Registered/SDS
Dte General Border Roads
Kashmir House
DHQ PO- New Delhi -110 001

55021/Tech Instr/DGBR/E4 Tech

DIRECTORATE GENERAL BORDER ROADS
GENERAL REPAIR INSTRUCTION NO. 141
ON
MODIFICATION OF OM NO 312 ENGINE
FOR FITMENT ON NISSAN 1 TON

MODIFICATION RADIATOR & MOUNTING AND FUEL TANK WITH LINES

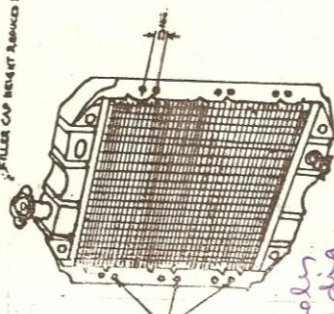
3. Refer DRG No. NSN-TMB/03

(a) Tata pt No 2523501001 radiator core (top water filling) be drilled holes as per DRG- ... for fitment in place of original NSN radiator core. Top cover shield provided on grill be cut and removed as per DRG 'A' Cut and remove starting handle bracket as per DRG 'B'.

Ref DRG 'D' (NSN-TMB/03)

(b) Fuel tank be modified by locking original outlet (Suction Nipple) with dome nut. Sction pipe with stainer be manufactured suitably so that is remains 38mm above bottom of tank when fitted. Suitable round plate of 70mm dia be taken. A Hole in centre be drilled to fit Tata Pt No. 141345580 reducing nipple, 8 holes of suitable size be drilled radically on plate and fuel tank for its fitments. Reducing nipple be gas welded with plate. Modified suction pipe be welded with reducing nipple. This modified suction pipe assy be screwed on the tank by providing a packing in between. Hollow screw and washer be used to connect suction fuel line as per DRG 'D'.

(c) To make overflow return fuel line connection fitting on tank, weld Tata pt No 1413455080 reducing nipple on tank, use hollow screw and washers to fit overflow return fuel line as per DRG 'D'.

(d) Suction and overflow return fuel lines of Tata be modified/aligned alongwith the chassis and be clamped.

MODIFICATION FRONT AXLE

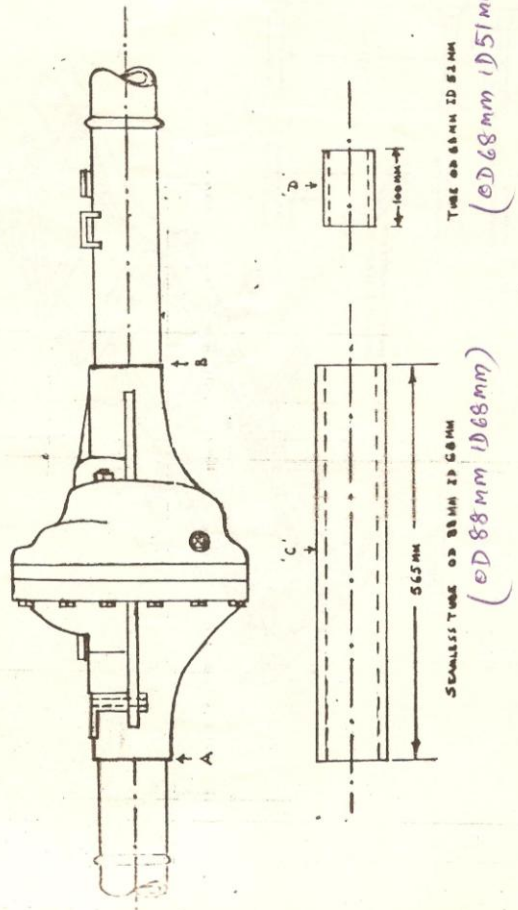
2. front axle of the vehicle be modified as dead axle as per DRG No NSN-TMB ENG/02. This has been done due to less space available between front axle differential housing and TMB engine sump and oil filter and to avoid chances of damages to engine during up/down movements of engine alongwith chassis due to road spring action.

1. REMOVE FRONT AXLE SHAFTS L.H. & R.H.
2. CUT FROM POINT 'A' & 'B' TO REMOVE DIFFERENTIAL HOUSING. REMOVE BUSHES FROM AXLE TUBES.
3. FIT TUBE 'D' IMMEDIATELY.
4. FIT TUBE 'C' TO JAM AXLE TUBE
5. WELD TUBE 'C' AND AXLE TUBES AT POINT 'A' & 'B'

PREPARATION & MODIFICATION OF CHASSIS FOR FITMENT OF TMB OM-312 ENGINE ON NISSAN CARRIER TRUCK, 1-TON, 4X4, D-4W73N

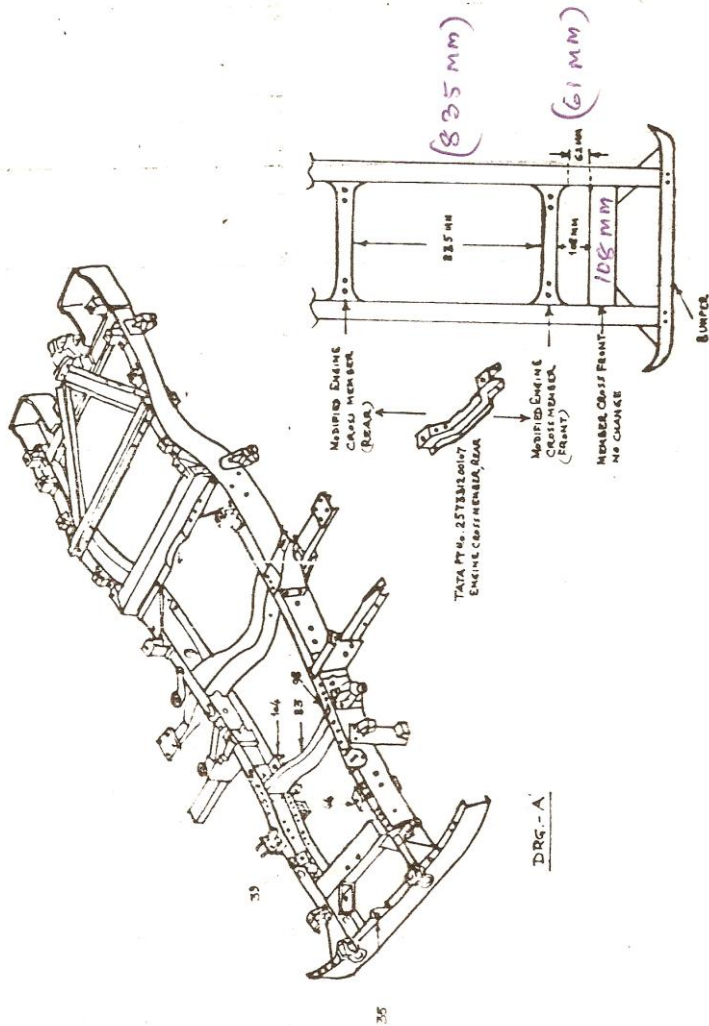
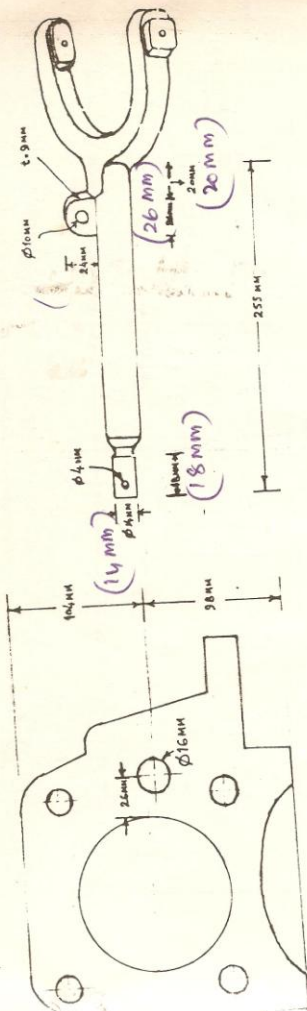
- (o) Engine mounting brackets front and rear, 2nd cross member and plate for starting handle guide be removed as per DRG No NSN-TMB ENG/01.

1. Modify chassis to fit Tata Pt No 2573.312.00107 engine cross member rear 2 Nos as per drawing No NSN –TMB Eng/01. Engine mounting pads of Tata to be used at front and rear. Cable mounting pads – 4 Nos should be raised to 45 mm by using additional suitable rubber pads.

REMOVE FOLLOWING PARTS DRG-A:

1. SUPPORT ENGINE FRONT, RU, FIG No. 39
2. SUPPORT ENGINE FRONT, LN, FIG No. 44
3. SUPPORT ENGINE REAR, RA, REF No. 98
4. SUPPORT ENGINE REAR, LB, FIG No. 144
5. MEMBER CROSS 2nd, FIG No. 83
6. PLATE STARTING HANDLE GUIDE FIG No. 35

FIT FOLLOWING PARTS OF TATA 1210SE VEH

1. PT No. 2578 310107 ENGINE CROSS MEMBER REAR-2ND BY WELDING AS PER SPACING GIVEN IN DRG-B. IN PLACE OF SUPPORTS ENGINE FRONT & REAR, RH & LH.

2. PT No. 2523 2410101 RUBBER MOUNTING LHM FOR FRONT ENGINE SUSPENSION - 2 Nos.

3. PT No. 2523 2410102 RUBBER MOUNTING FOR REAR ENGINE SUSPENSION - 2 Nos.

NOTE - CABIN MOUNTING PADS - 4 Nos READ TO BE GAUGED TO 45MM, RADIATOR BKT MOUNTING TO BE RAISED BY 10MM BY USING SUITABLE RUBBER PADS ADDITIONALLY.

MODIFICATION CLUTCH FORK ITS MOUNTING ON CLUTCH HOUSING & CLUTCH LINKAGES

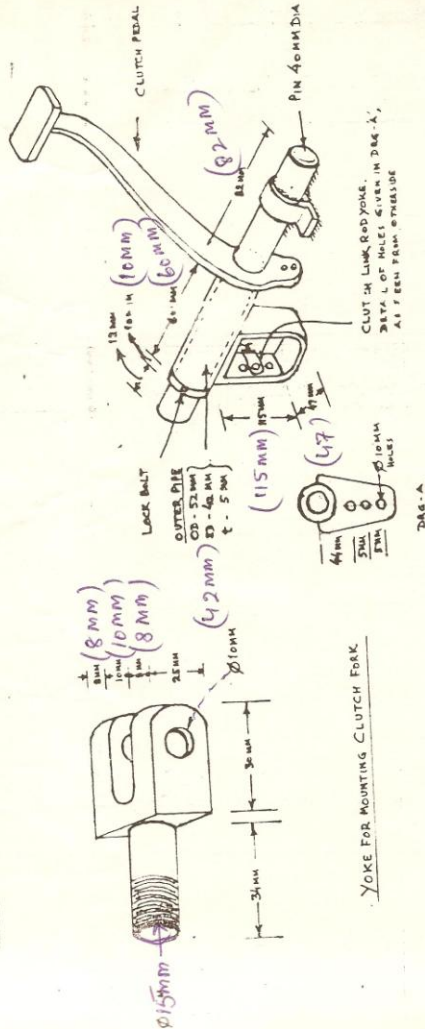
3. Ref DRG No NSN-TMB/04

(a) Tata pt No 257325605106 clutch fork be modified as per dimension given In drawing.

(b) Yoke for mounting modified clutch fork be manufactured as per dimension given in drawing.

- (c) A hole 16 mm dia be drilled in clutch housing of TMB OM 312 engine as per dimension/loc given in drawing to fit yoke.
- (d) Yoke be fitted on clutch housing from inside and tighten the nut.
- (e) Fit modified clutch fork inside clutch housing on yoke and tighten nut/bolt for locking it with yoke.
- (f) Remove clutch pedal and linkages from original position modify/manufacture linkages assy as per drawing and weld the pin on chassis with a modified clamp. Location on longitudinal member of chassis inline with hanger step front. RH Fig No. 132 pt No. 96117-43700. The distance between the chassis and clutch pedal is 18 mm.

1. DRILLING HOLE IN THE ENGINE CLUTCH HOUSING TO FIT YOKE FOR MOUNTING CLUTCH FORK

1. CLUTCH LINKAGES AND CLUTCH FORK NEED TO BE MODIFIED DUE TO LACK SPACE AVAILABLE WITH EXISTING LINKAGES.
2. CLUTCH FORK BE MODIFIED AS PER DIAG.
3. A HOLE 10MM DIA BE DRILLED ON CLUTCH HOUSING AS PER DIMENSIONS GIVEN IN DIAG.
4. A YOKE AS PER DIAG BE MANUFACTURED TO FIT CLUTCH FORK. THIS YOKE WILL BE FITTED INSIDE CLUTCH HOUSING THROUGH 10MM DIA HOLE WITH NUT. (ORIGINAL CLUTCH FORK MOUNTING/ BE DISCARDED)
5. CLUTCH MOUNTING BOWSET & PIN FITTED ON CHASSIS ORIGINALLY SHOULD BE ABANDONED.
6. MODIFIED CLUTCH LINKAGES PIN BE WELDED ON CHASSIS WITH CLAMP. LOC - ON LOWER TUBULAR MEMBER IN LINE TO HANGS STEP PIN 84, F & No 733, P/No 56177-45700
7. CLUTCH LINK ROD BE MODIFIED AS PER REQUIREMENT.
